Access Compliance Report

Public Rights-of-Way

(Curb Ramps)

Intersection ID: 11082	Main Street: E_35TH_ST	Cross Street: MURDOCK_RD	Location: NW
ADA ID: 842D6D7C004B	Ramp Type: Perp	Initial Pass/Fail: Fail	Overall Compliance: No
			Severity Score: 21.25

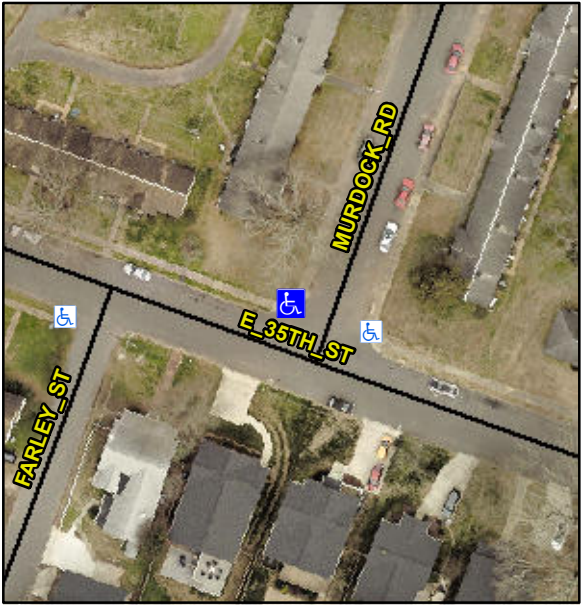
Codes/Mitigation Info/Possible Solution			Field Measurements/Component Compliance		
	Possible Solutions:		Compliance	Description	Data
	Remove & Replace Entire Ramp.		N/A	Ramp Length (in)	61.0
			No	Ramp Width (in)	46.0
			N/A	Flare Type LT	N/A
			N/A	Flare Slope LT (%)	N/A
			N/A	Flare Traversable LT?	N/A
			N/A	Landing Length (in)	N/A
			N/A	Landing Width (in)	N/A
			N/A	Landing Slope (%)	N/A
			N/A	Landing X Slope (%)	N/A
Surveyor Notes: N/A PROW/ADA: Not Found, R304.5.1, R304.5.3			N/A	Flare Type RT	N/A
			N/A	Flare Slope RT (%)	N/A
			N/A	Flare Traversable RT?	N/A
			N/A	DWS Provided?	N/A
			N/A	DWS Contrast?	N/A
			N/A	DWS Length (in)	N/A
			N/A	DWS Full Width?	N/A
			N/A	DWS Offset (in)	N/A
			N/A	Shared Landing?	N/A
			N/A	Gutter Ponding?	N/A
			N/A	Gutter Lip Ht (in)	N/A
			N/A	Painted X Walk1?	No
				X Walk 1 Direction	To SE
			N/A	X Walk 1 Width (in)	N/A
				X Walk 1 Slope (%)	3.2
				X Walk 1 X Slope (%)	0.3

N/A	Ramp inside XWalk1?	N/A
				Road Slope (%)	N/A
				Road X Slope (%)	N/A
			N/A	Any Obstructions?	N/A
				Obstruction Type	
Total Cost:		\$ 1850.00			
			N/A		N/A
			Yes	Surface Condition? (G/P)	Good
